Contract Program: **Technical Support for the Reactor Systems Branch (L1697/P2)**

Subject of Document: **Review of Proposed Modifications to Emergency Procedure Guidelines for Anticipated Transients Without Scram Events**

Type of Document: **Technical Evaluation Report**

Date of Document: **November 1995**

Figure 1. Suppression pool temperatures calculated by TRAC-BF1 following a MSIV isolation ATWS. Downcomer level is maintained at either MSCWL or TAF + 5'.

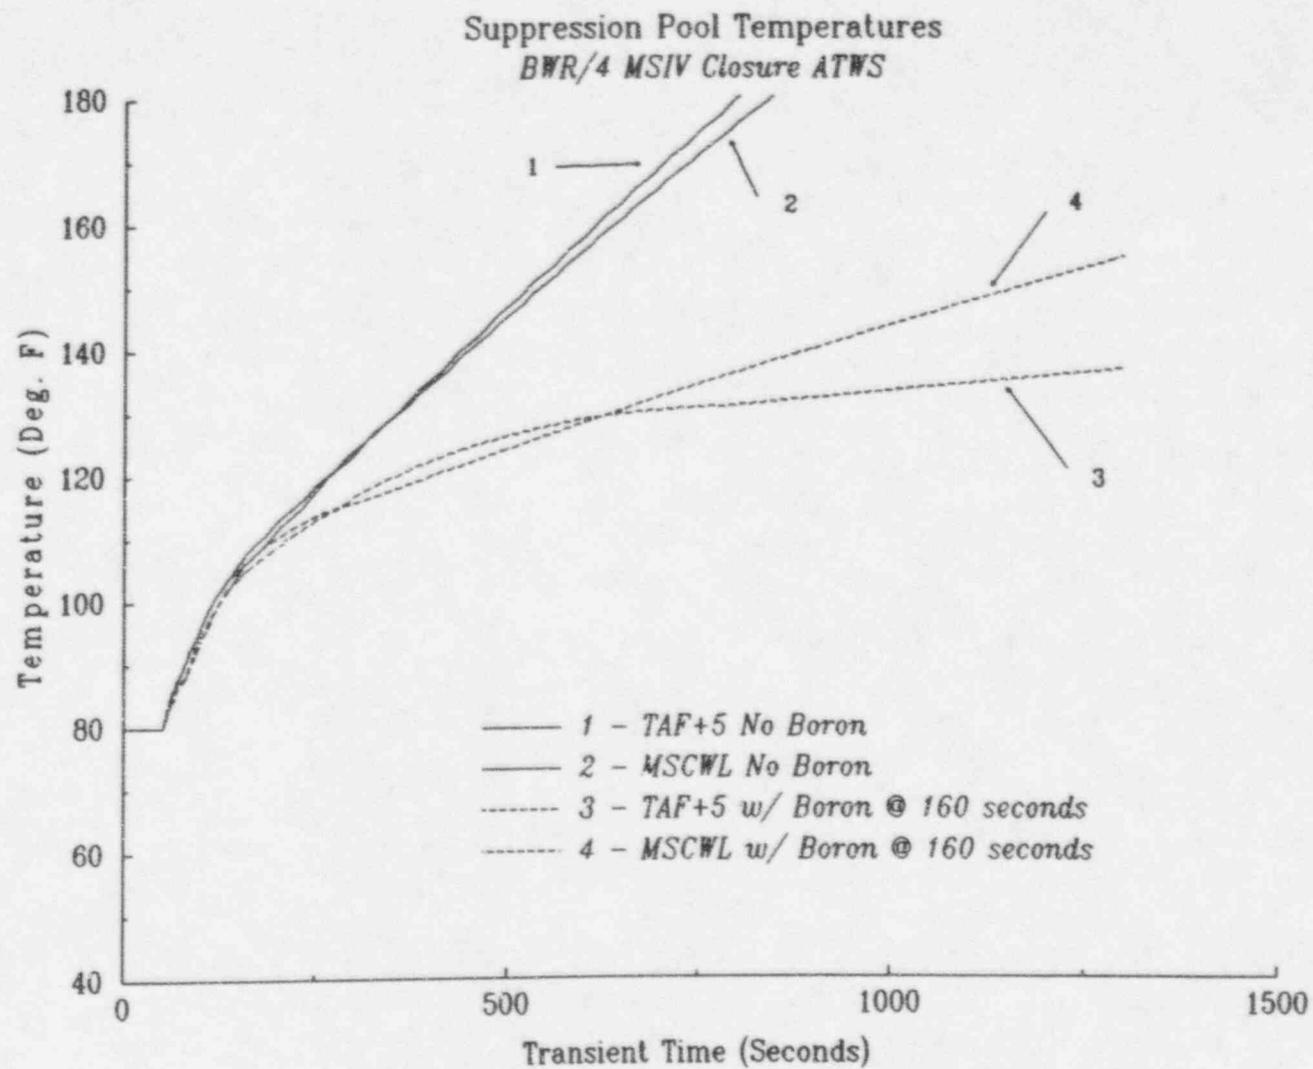
As it can be observed in Fig. 1, the staff calculations indicate that the higher-level strategy (TAF + 5') results in a lower suppression pool temperature than the low-level (MSCWL) strategy. This calculation also indicates that, as long as the hot shutdown boron weight (HSBW) is injected in approximately 20 minutes and the stratified boron is remixed promptly when the level is raised, the difference between the two level-control strategies is not significant in the sense that both strategies have sufficient margin to the heat capacity temperature limit (HCTL) and result in safe shutdown of the reactor. The results shown in Figure 1 also indicate that, if boron injection fails, both strategies reach the HCTL in 10 to 15 minutes and the difference in performance between the two strategies is not large.

The results of the staff calculations also indicate the need for immediate water level reduction once an isolation ATWS event is identified. As seen in Figure 1, the suppression pool is heating up very rapidly for the first few seconds when the level and power generation is high; thus, relatively small changes in assumptions for timing of operator actions in this phase of the transient result in very large discrepancies in the final suppression pool temperature. For example, the calculations reported in ref. 7 indicate that if the operator does not take immediate control of feedwater flow and other injection sources, the suppression pool reaches close to 150°F before the level is lowered and the pool heatup rate is reduced. Staff analyses based on the calculations of ref. 7 indicate that if the EPG procedures (which require prompt operator action) had been followed the final pool temperatures calculated by SABRE for the two level strategies would have been similar to the ones shown in Figure 1.

Figure 2. Comparison of power levels during a MSIV closure ATWS with water level control at MSCWL versus TAF + 5'. Power oscillations are caused by SRV actuation.

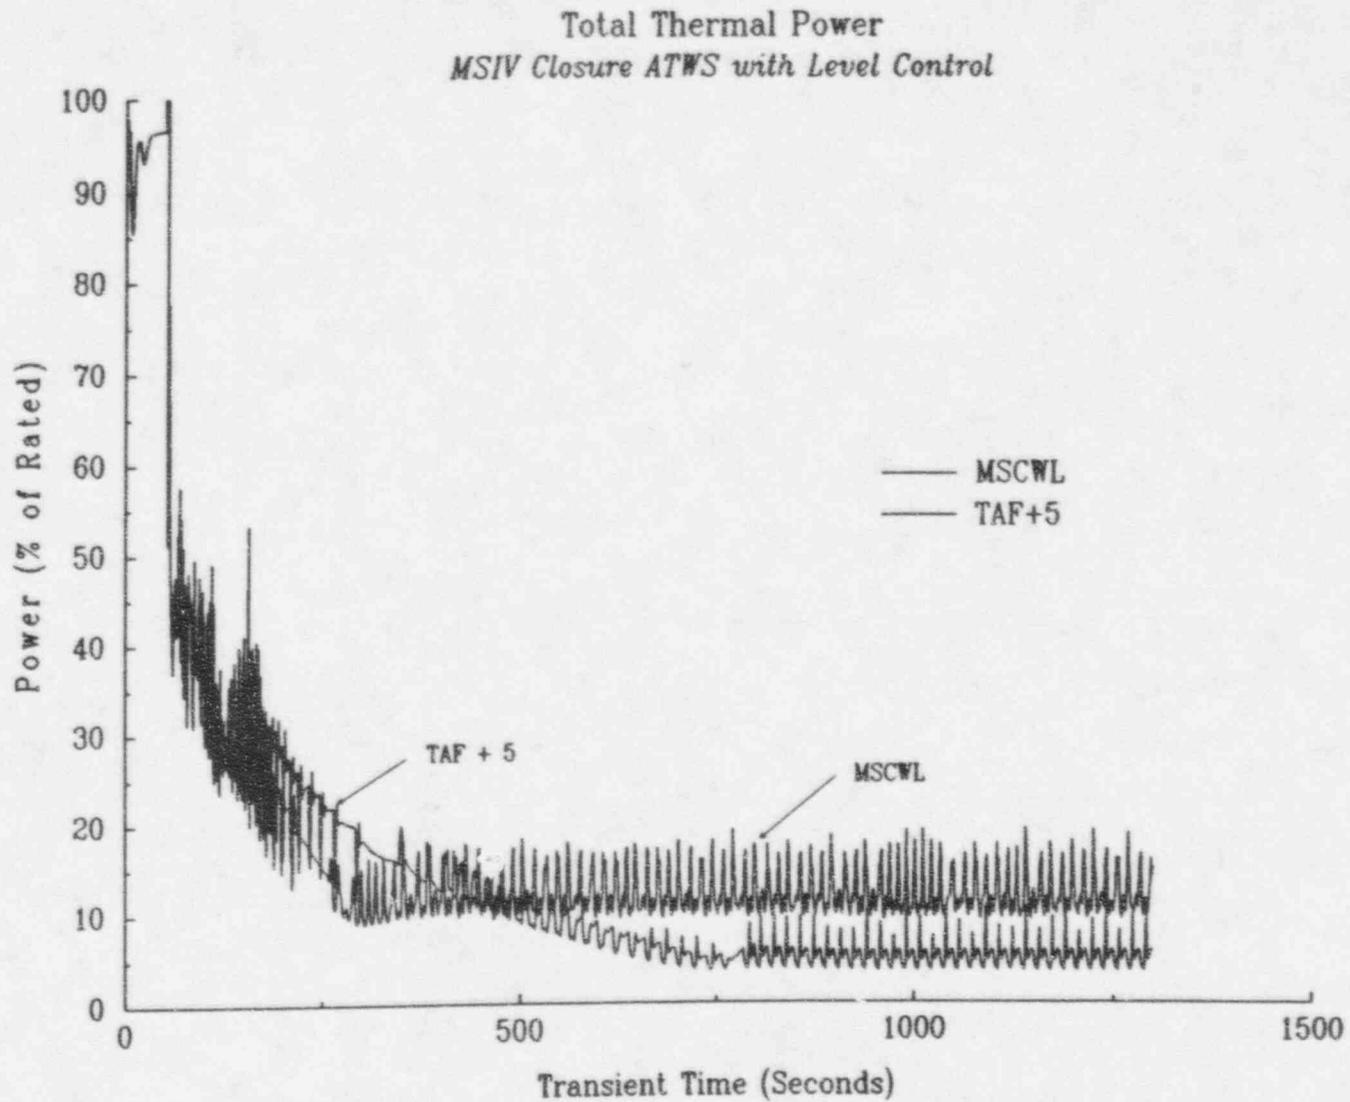
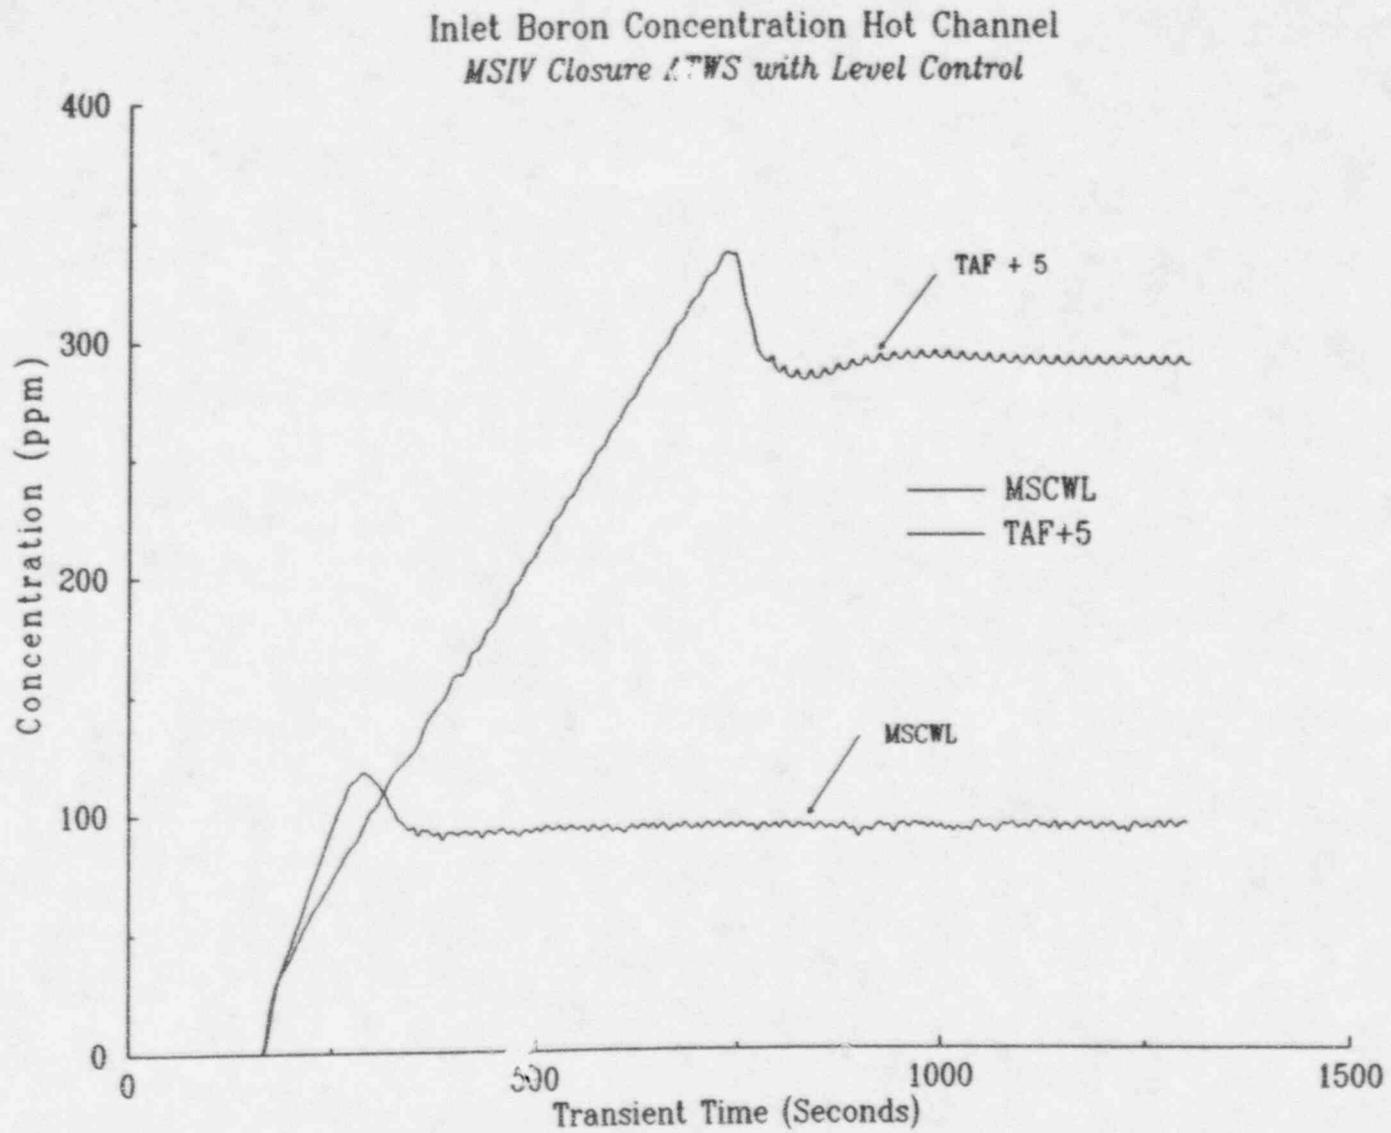
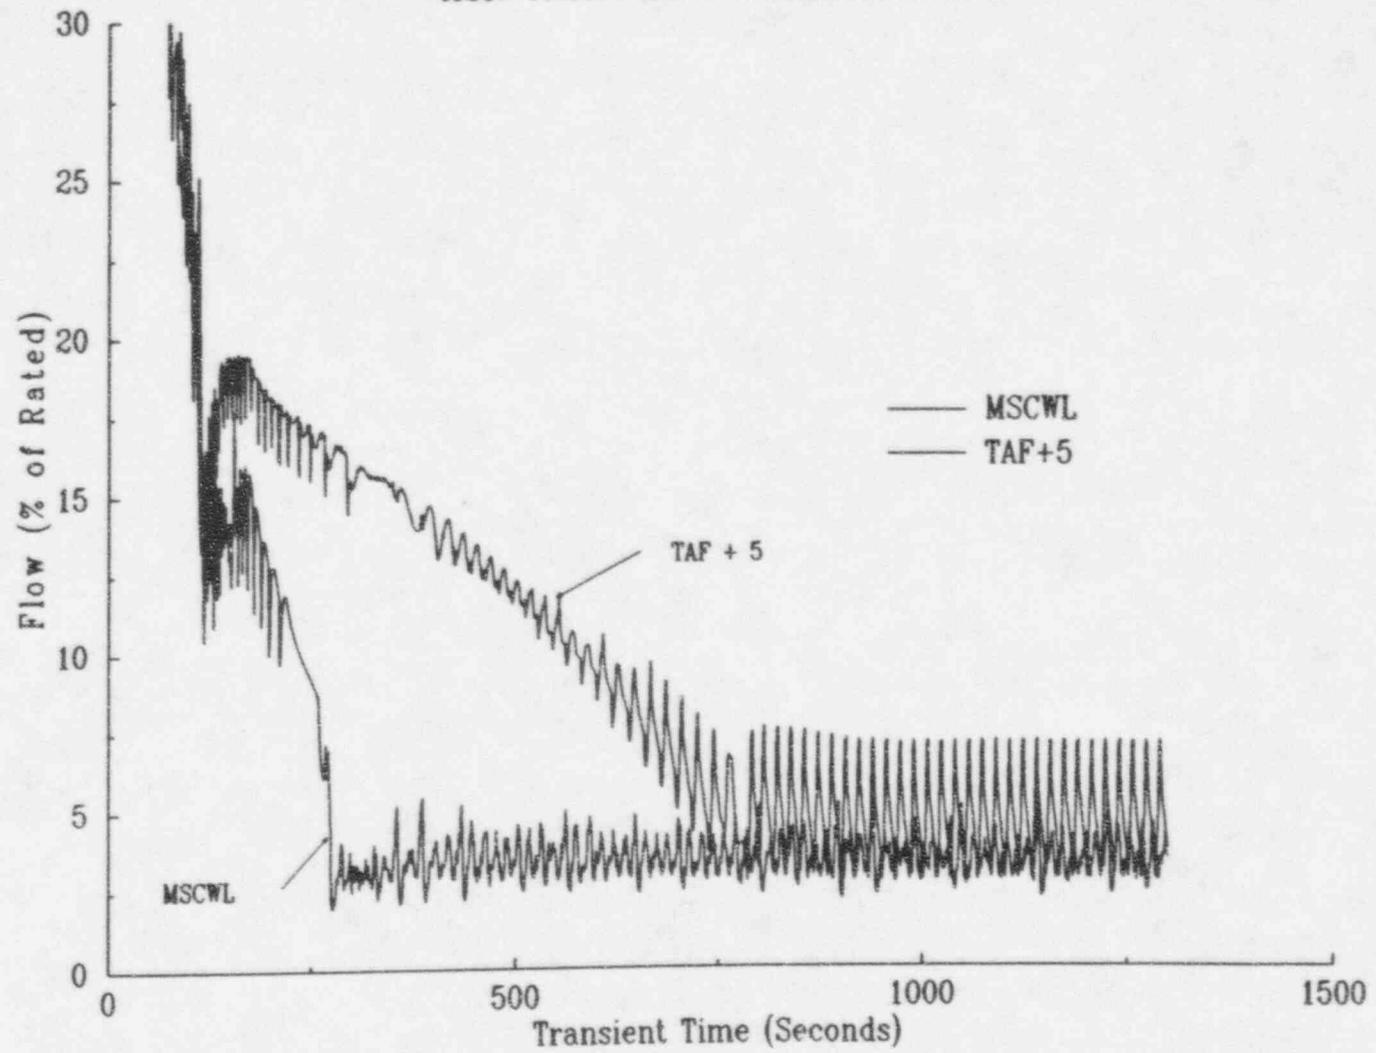
Figure 2 shows the core power calculated by TRAC-BF1 for the same MSIV isolation ATWS events represented in Figure 1, and Figure 3 shows the core boron concentration for the two strategies. These two figures show more clearly the advantage of the higher-level strategy. As a consequence of maintaining the high level, the power generation is higher for the first 500 seconds, but after that the power drops significantly below the MSCWL case, because boron continues to be mixed for 750 seconds until a concentration of 300 ppm is reached. This boron concentration is sufficient to reduce the power and drop the flow to 5% (the flow at which boron is assumed not to mix), as seen in Figure 4.

Figure 5. Comparison of core average void fraction for a MSIV closure ATWS event with two different level control strategies.

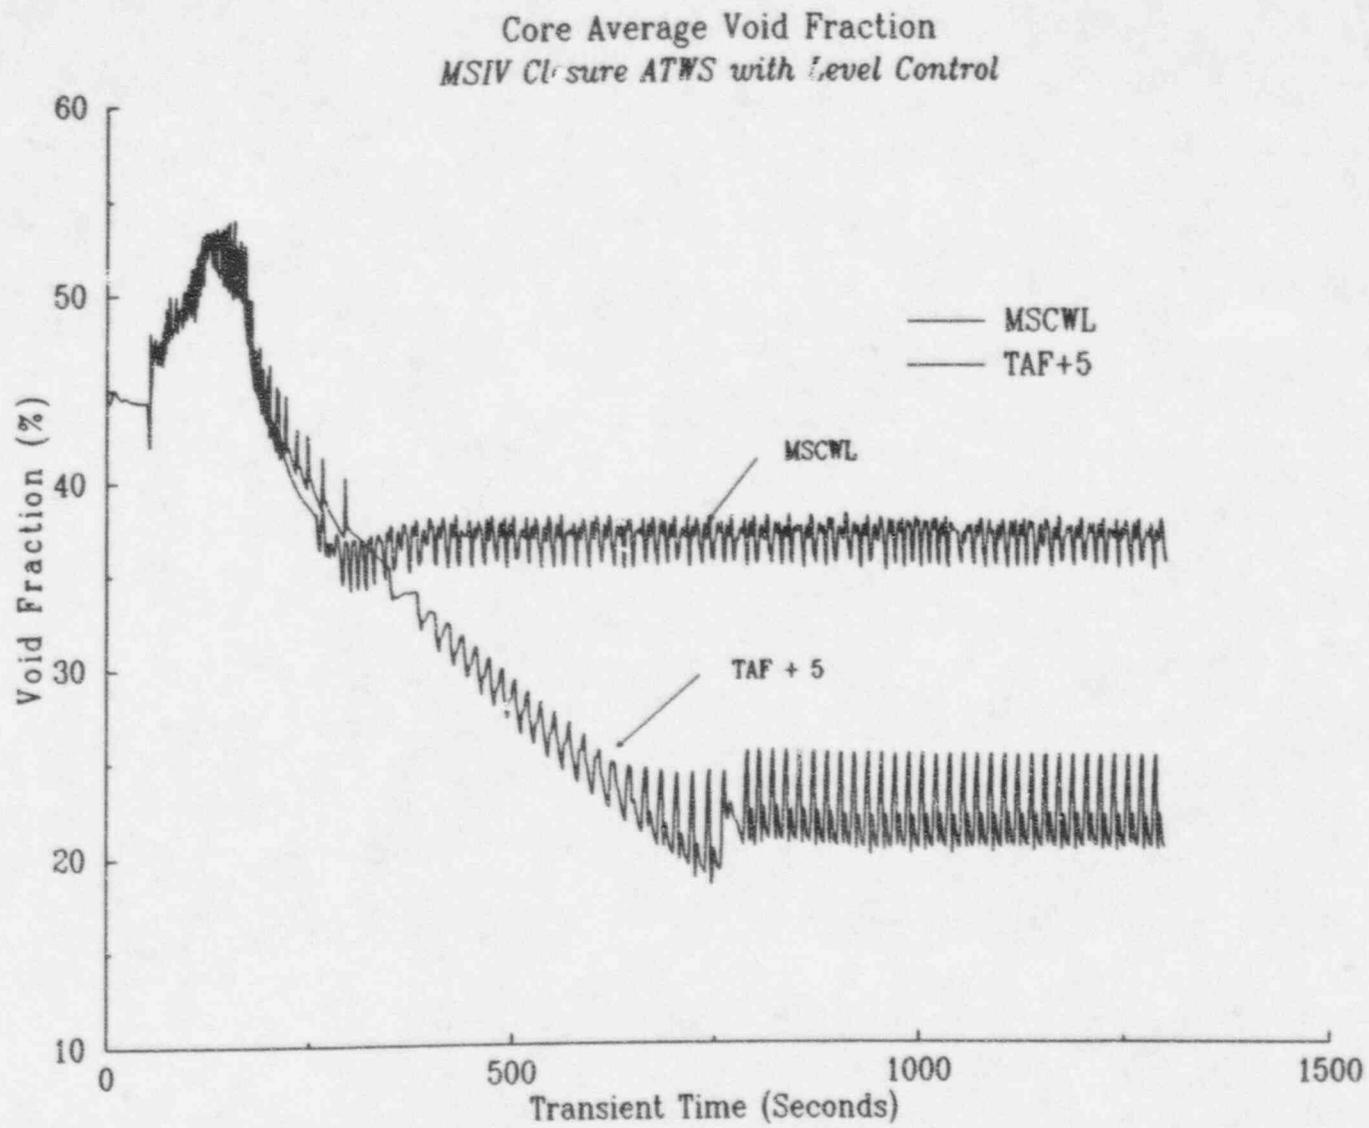
Figure 5 shows the core average void fraction for the two level-control strategies studied. This figure shows that as expected, to maintain the level at MSCWL, the reactor requires a higher void fraction than when the level is higher at TAF + 5'; thus, a higher power is required at the lower level to maintain the same flow (approximately 5%).

The NRC calculations have also shown that the two-phase level is well-above the core (indeed, in most cases, the two-phase level is at the separator level) even when the level is at the MSCWL. As seen in Figure 5, the core average void fraction is lower with the level at MSCWL than at nominal conditions (time zero in Figure 5). This fact indicates that the core is likely to be covered with a two-phase mixture. The core coolability is confirmed by studying the peak clad temperatures calculated by TRAC-BF1. Figure 9 represents a composite of ten different TRAC-BF1 calculations, and it shows the maximum clad temperature in the low-power channel (expected to have the limiting performance). This set of TRAC-BF1 calculations includes collapsed water levels from TAF + 5 to MSCWL, and it shows that the clad temperature is well within acceptable limits. Indeed, for most transients, the peak clad temperature is lower than at rated conditions (time zero).

Figure 6. TRAC-BF1 and RAMONA-4B calculated power as a function of downcomer water level with 25 °C feedwater. Sharp drop in power at TAF - 40" (TRAC-BF1 calculation) corresponds to flow stagnation.

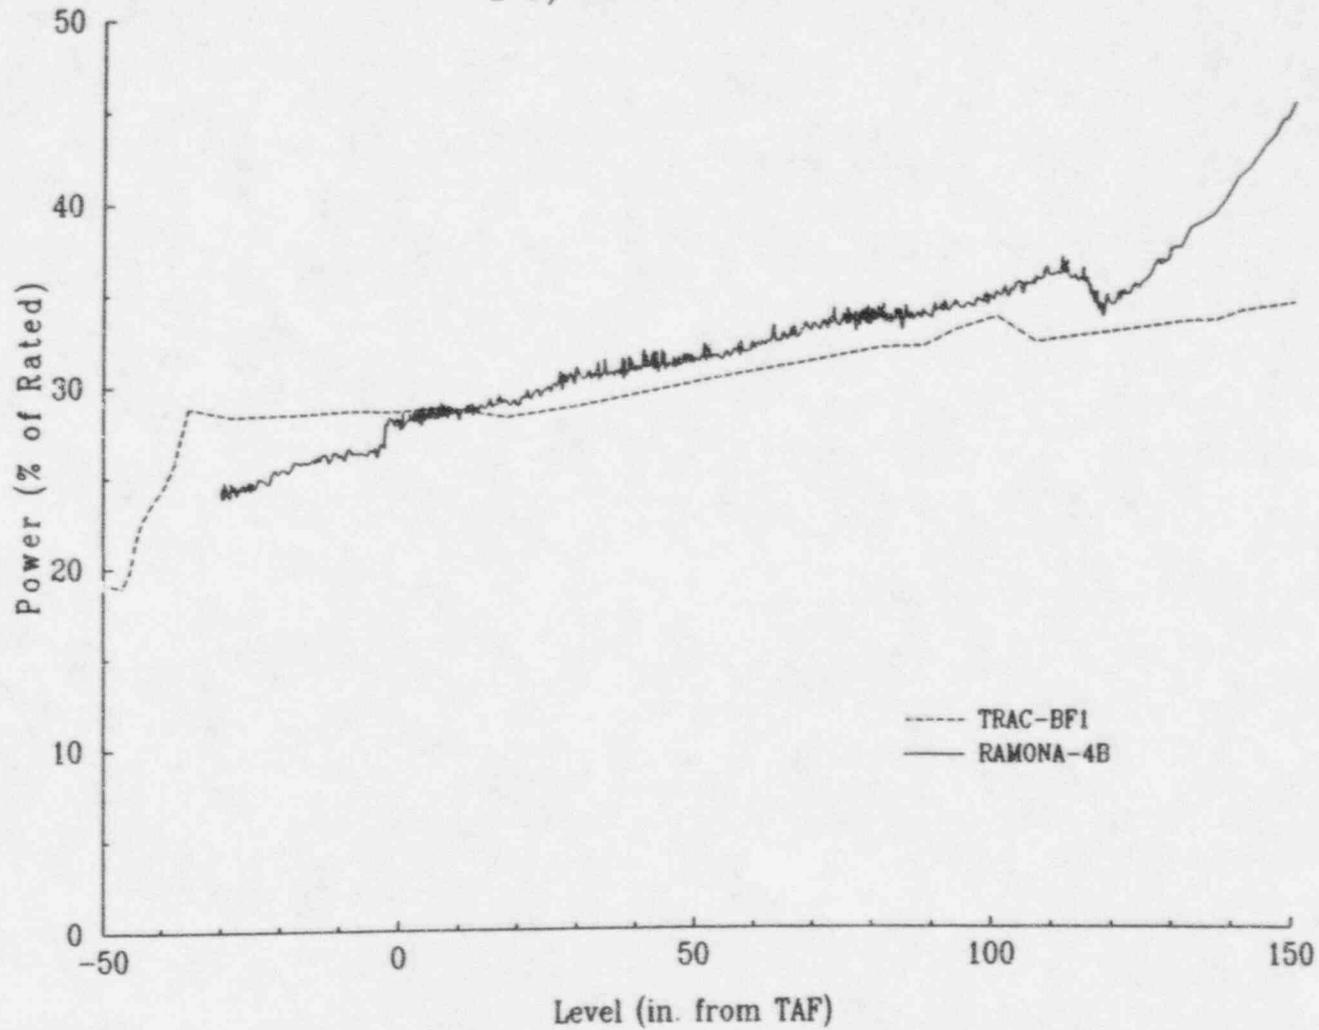
An unexpected result of the staff calculations is the small dependency observed between power and level once the level is lowered below TAF + 5'. Figure 6 shows the core thermal power as function of downcomer water level. This figure has been produced by plotting the power and level during a TRAC-BF1 and a RAMONA-4B calculation in which the feedwater flow is slowly ramped down to zero. We can observe that both codes, TRAC-BF1 and RAMONA-4B, predict that the dependency between power and water level is fairly flat around the TAF area. This is the reason why the differences between the two level strategies are not as large as expected when the SLC system fails.

The sharp step change in power seen in the TRAC-BF1 calculation shown in Figure 6 at around TAF - 40" corresponds to the stagnation of the external flow recirculation path. The RAMONA-4B calculation (which does not correspond to the same reactor or initial conditions that the TRAC-BF1 calculation) predicts slightly higher recirculation flows than TRAC-BF1 and does not predict flow stagnation even for a water level as low as the top of the jet pumps (TAF -50"). For levels below TAF - 40", the core inlet flow is greatly reduced and equals only the flow of steam leaving the core; this results in a significantly lower power. The value of the flow-stagnation power calculated by TRAC-BF1 is slightly less than 20%. This number was previously assumed to be of the order of 8% based on an extrapolation of a number of REDY analyses.¹⁰ The larger value of the flow-stagnation power is consistent with other BWROG calculations² and is attributed to the fact that REDY uses a multiplicative slip void model, which is incapable of predicting accurately the void fraction distribution under flow-stagnation conditions.
